Facility Advisory Committee (FAC) Closeout - General Aspects

LCLS Facility Advisory Committee

31 October 2007

PROJECT SAFETY EXPERIENCE 30 September 2007

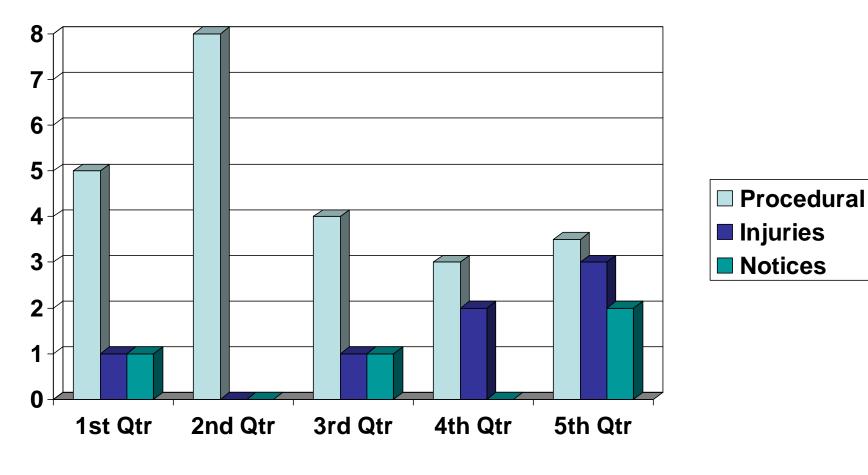
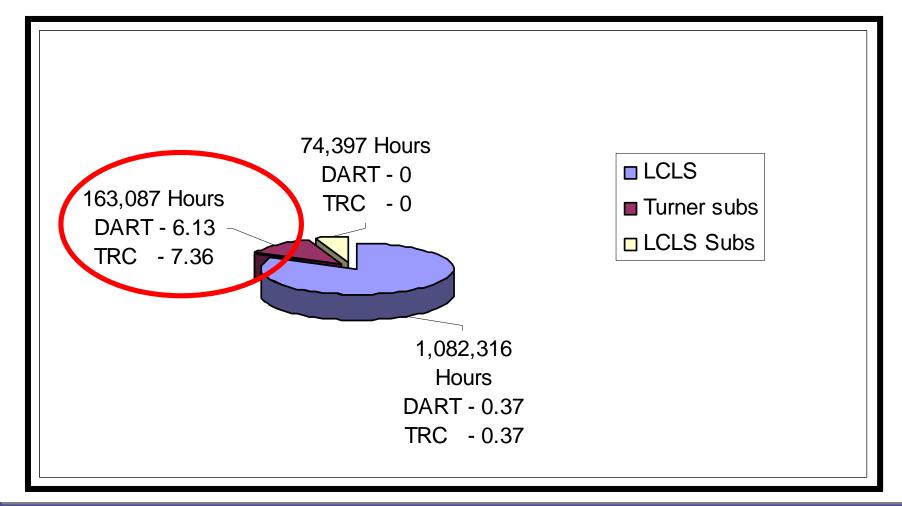
- Construction Safety
 - Turner's safety performance should not be accepted
 - A corrective action plan has been implemented
 - Management Safety Walks
 - Look-Ahead Schedule
 - Job Safety Analysis QA
 - This action plan has not produced positive results
 - The risk of problems in this area requires immediate action

Recommendation #5: Reassign the best available CF staff to support Turner line managers in the field in directing safety activities
